Access Compliance Report

Public Rights-of-Way

(Curb Ramps)

Intersection ID: 9221	Main Street: JOYCETON_ST	Cross Street: PRITCHARD_ST	Location: W
ADA ID: 39E347DDA673	Ramp Type: Perp	Initial Pass/Fail: Fail	Overall Compliance: No
Severity Score: 8.75			
Codes/Mitigation Info/Possible Solution		Field Measurements/Component Compliance

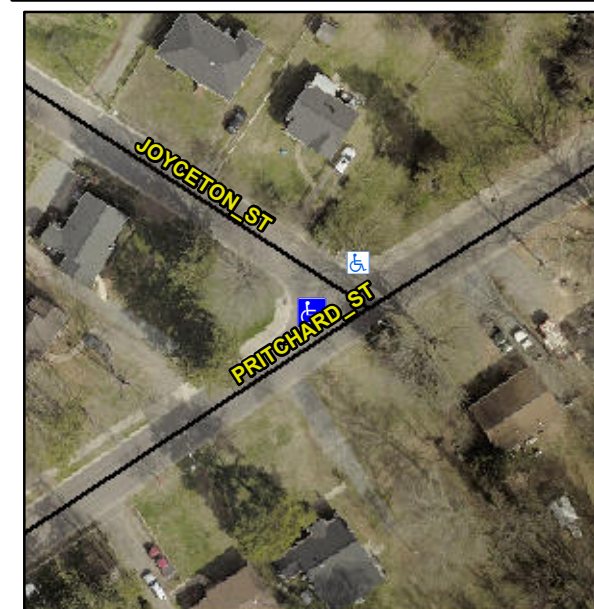
Not Found, R304.5.1

Compliance	Description	Data	Compliance	Description	Data
N/A	Ramp Length (in)	73.0	Yes	Ramp Slope (%)	5.0
No	Ramp Width (in)	46.5	Yes	Ramp XSlope (%)	0.1
N/A	Flare Type LT	N/A	N/A	Flare Type RT	N/A
N/A	Flare Slope LT (%)	N/A	N/A	Flare Slope RT (%)	N/A
N/A	Flare Traversable LT?	N/A	N/A	Flare Traversable RT?	N/A
N/A	Landing Length (in)	N/A	N/A	DWS Provided?	N/A
N/A	Landing Width (in)	N/A	N/A	DWS Contrast?	N/A
N/A	Landing Slope (%)	N/A	N/A	DWS Length (in)	N/A
N/A	Landing X Slope (%)	N/A	N/A	DWS Full Width?	N/A
N/A	Landing Curb? (Y/N)	N/A	N/A	DWS Offset (in)	N/A
N/A	Shared Landing?	N/A			
N/A	Gutter Ponding?	N/A	N/A	Gutter Slope (%)	N/A
N/A	Gutter Lip Ht (in)	N/A	N/A	Gutter X Slope (%)	N/A
N/A	Painted X Walk1?	No	N/A	Painted X Walk2?	N/A
	X Walk 1 Direction	To NE		X Walk 2 Direction	N/A
N/A	X Walk 1 Width (in)	N/A	N/A	X Walk 2 Width (in)	N/A
	X Walk 1 Slope (%)	2.2		X Walk 2 Slope (%)	N/A
	X Walk 1 X Slope (%)	2.2		X Walk 2 X Slope (%)	N/A

Remove & Replace Entire Ramp.
